City of Franklin

Franklin Municipal Planning Commission

Thursday, December 20, 2018

8. [18-1099](#) PUBLIC HEARING: Consideration Of Resolution 2018-96 - A Resolution Approving A Development Plan For The Fields At Reese Farm PUD Subdivision For The Property Located North Of Del Rio Pike And West Of Reese Drive, 2970 Del Rio Pike. (12/20/18 FMPC 6-2; 1/08/19 WS)

**131. Sidewalk Access in Open Space**

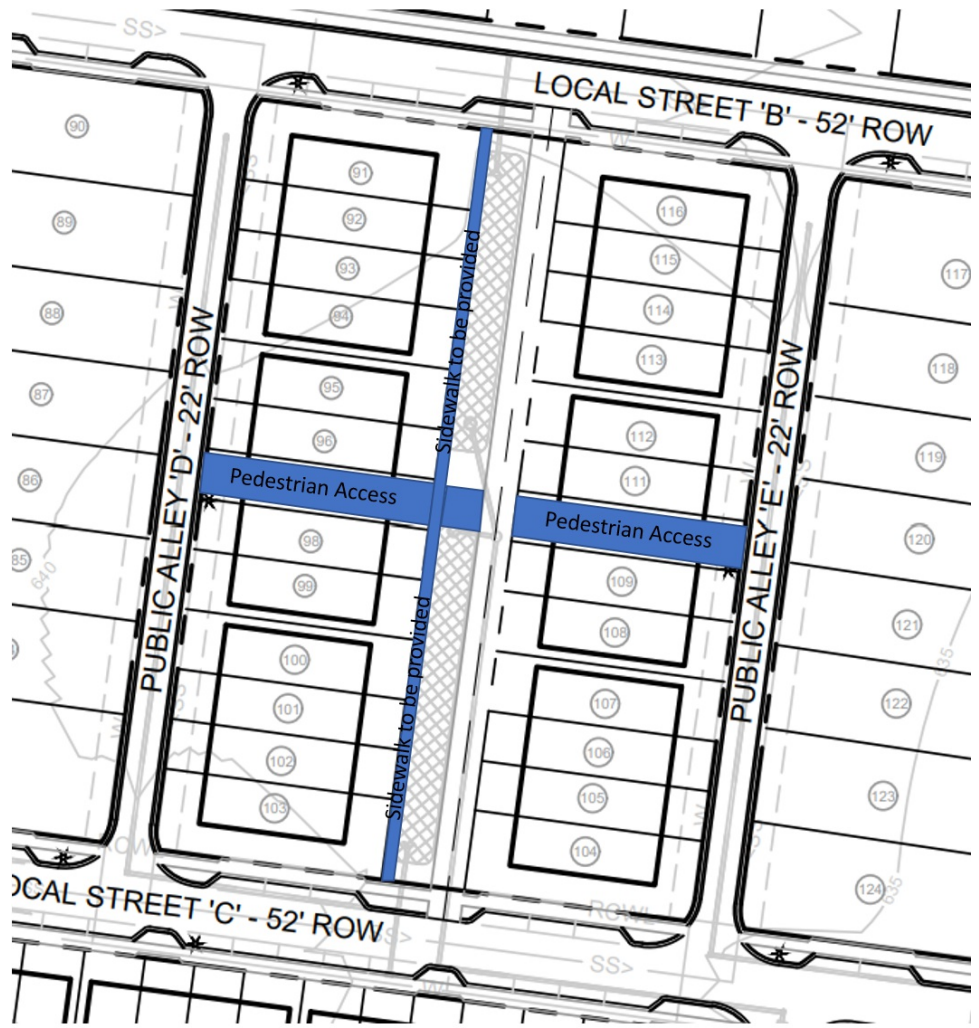
christopher.andrews@franklinton.gov Sidewalks shall be added to both sides of the rectangular open space in the northern portion of the development depicted below, which runs primarily north to south, and where townhouses front from both sides; and that pedestrian access be provided, running generally east to west, in between the proposed row of townhouses. The applicant recognized that as a result of this condition, a reduction in the number of buildable lots may occur.

132. Lot Number for Open Space

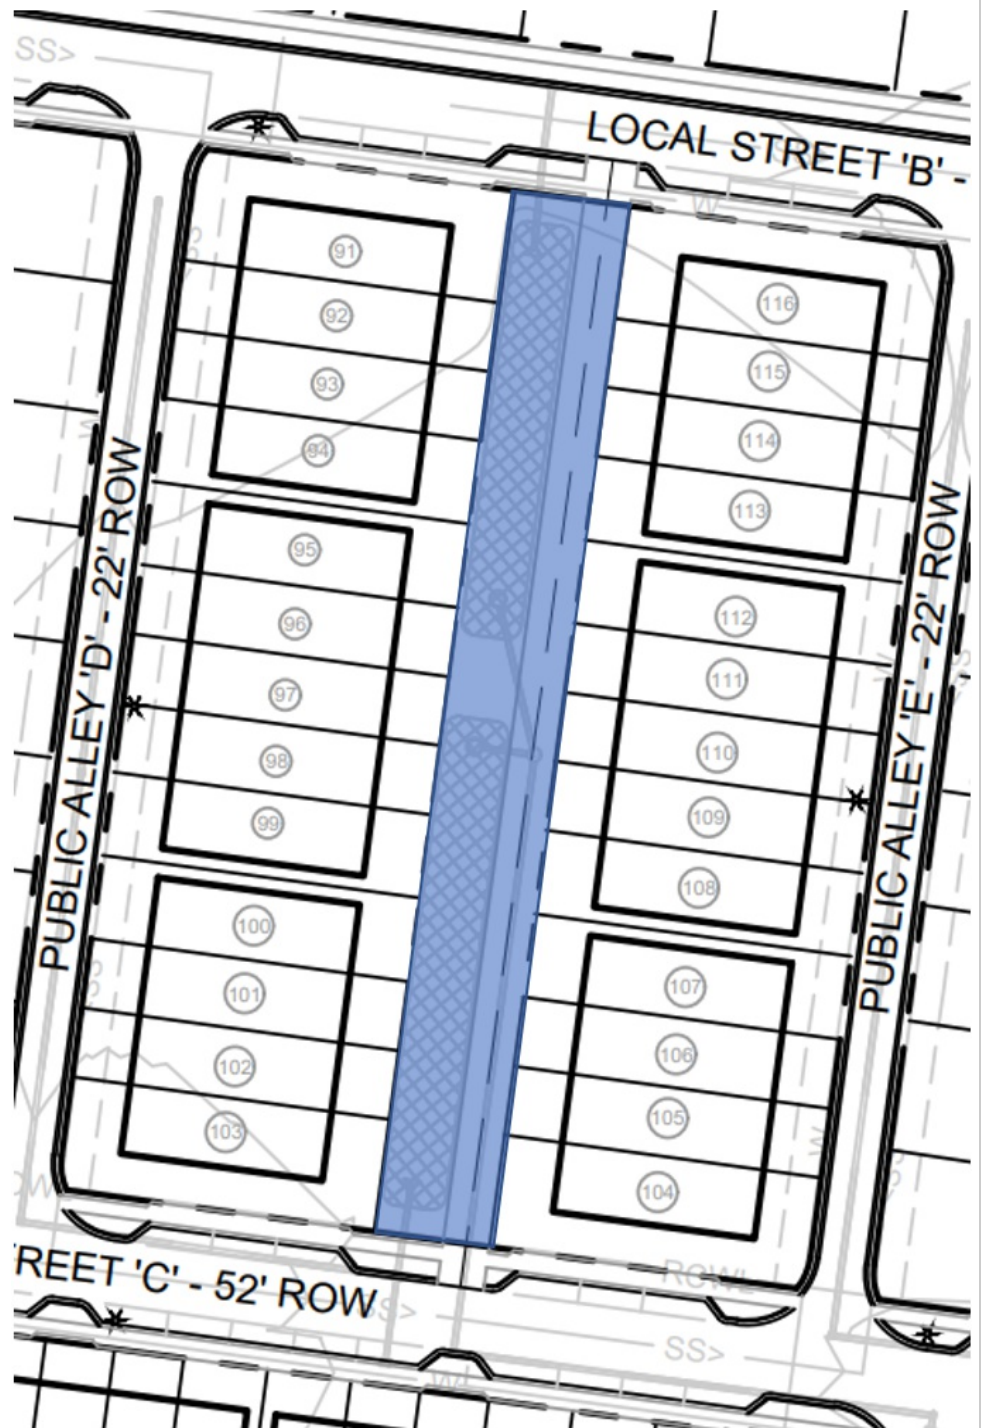
christopher.andrews@franklinton.gov Please provide a lot number for the linear open space shown below:

133. Lots Fronting Open Space / Stream

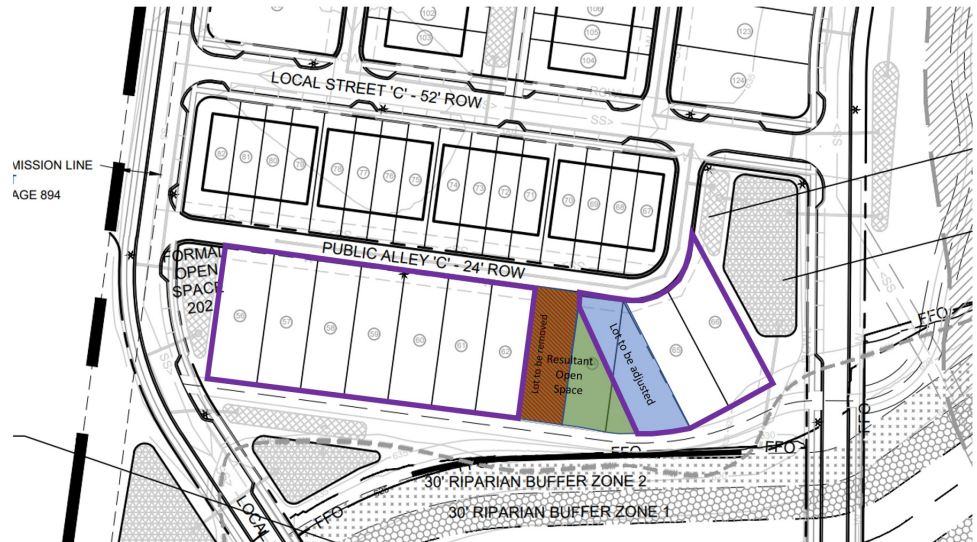
christopher.andrews@franklintn.gov Lots with frontage along the open space containing the stream and that take rear access from proposed "Alley C" as labelled on the development plan shall be modified. Removal of Lot 63 as currently labelled on the development plan, along with the shifting of Lot 64 to be adjacent to Lot 65 helps to satisfy staff concerns related to addressing. Changes to the block layout shall be representative of the depiction below. The applicant recognizes that these changes may lead to the loss of buildable lots.

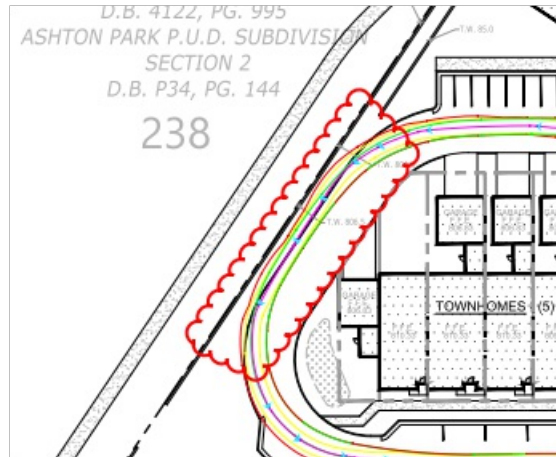
Applicant to correct the Autoturn on C4.17 such that the apparatus wheels are always on pavement.

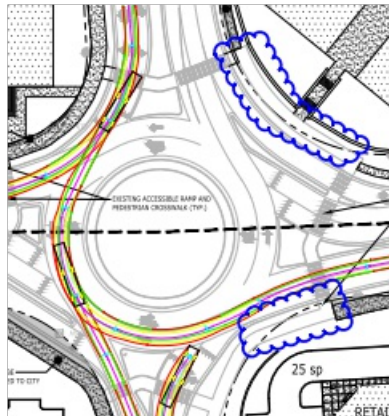
4. Show 'Future ROW' for the 12 feet needed for the additional lane at the south leg of the roundabout, per the TIA review. (C4.0, 4.14)

5. Show "Future ROW" for the sidewalks clouded below at the E. McEwen Drive / Cool Springs Blvd Intersection. (C4.14)

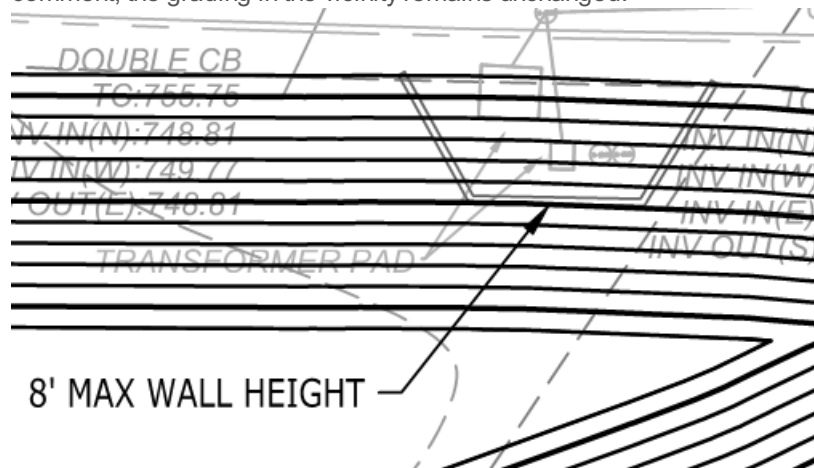
lance.fittro@franklin.tn.gov The previous comment has largely been addressed (thank you), but the box shown below which persists on sheet C3.18 shall be removed:

and another reference to TSS removal requirements remains in the narrative on sheet C3.01:

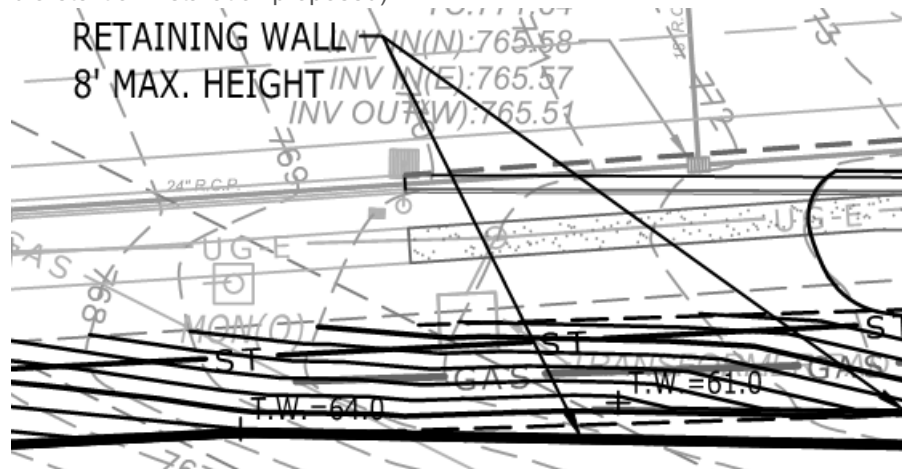
While a wall has been added around the transformer pad to address the previous comment, the grading in the vicinity remains unchanged:

A similar issue persists with the next transformer pad to the east (adjacent to the large bioretention installation proposed):

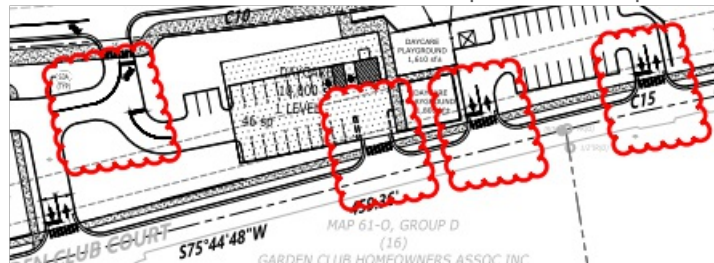
Advisory Comment: At Site Plan, the Applicant will be required to revise the drives and accesses clouded below to meet Street Specification requirements. (C2.15)

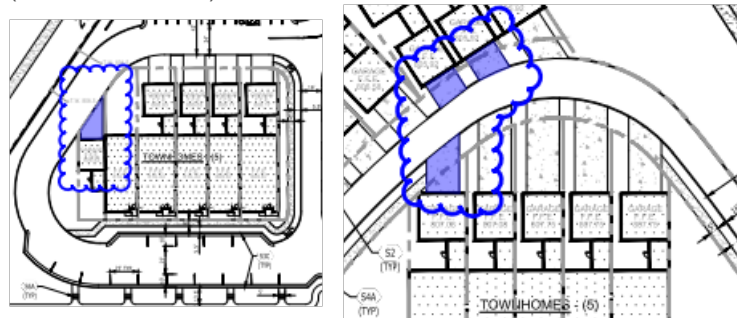
Advisory Comment: At Site Plan, the Applicant will be required to revise driveways such that all portions of driveway lengths are either 5 feet or less, or 20 feet or more, from the edge of pavement to the face of garage, including those highlighted below. (C2.17 and C2.18)

28. Line Weight

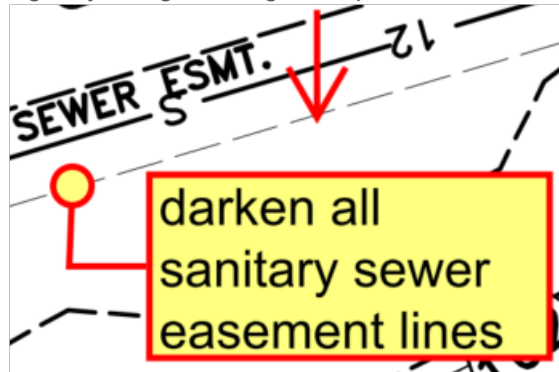
jimmy.wiseman@franklintn.gov Comment not adequately addressed.
Some line weights for sanitary sewer easement lines appear darker than others. Applicant to darken all lighter sanitary sewer easement lines to help ensure legibility during scanning and reproduction.

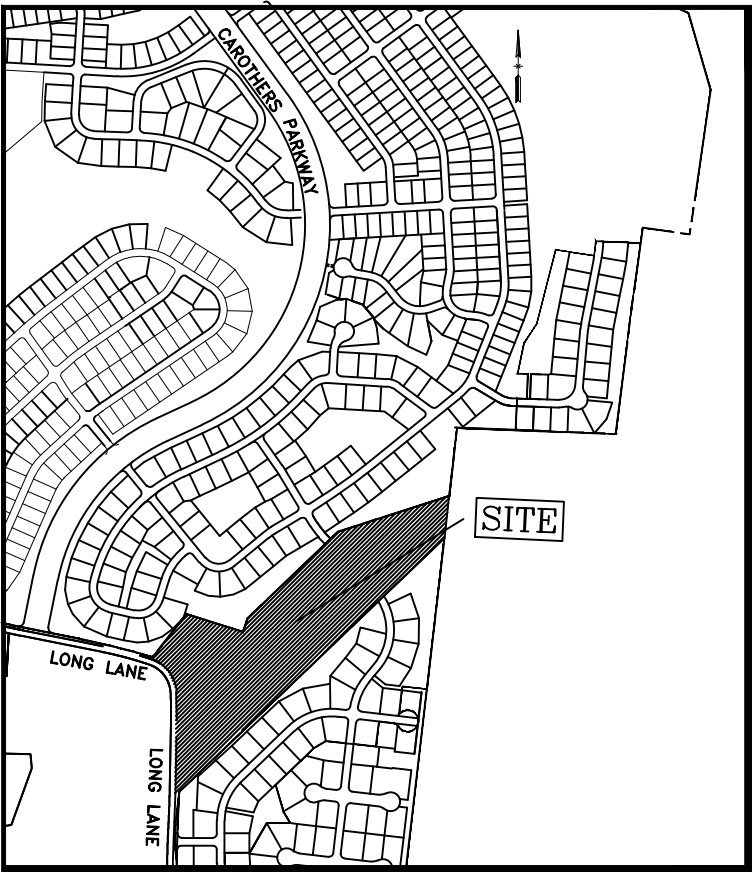
jeff.willoughby@franklintn.gov Note 8 has note been revised as requested.

Please revise riparian buffer note 8 to state:

15. C. Final Plat

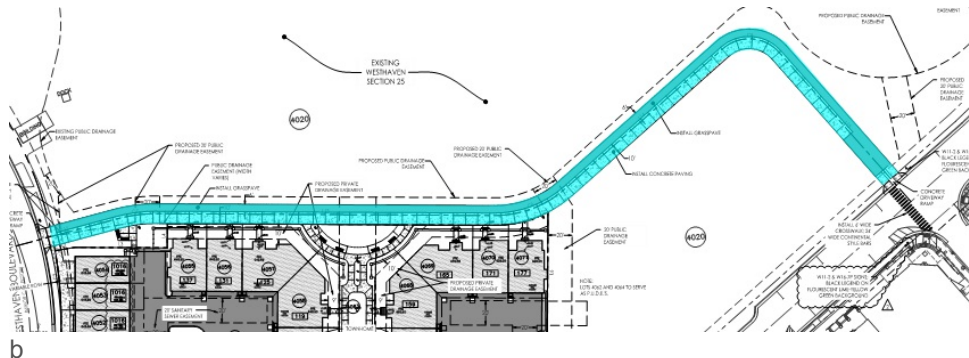
lance.fittro@franklinton.gov Applicant shall provide Emergency Access Easement for the 10' sidewalk and 6' grasspave section (16' total easement width) that loops around the lake side of the condos and future retail portion of the development (highlighted in blue in the below snippet from the site plan).
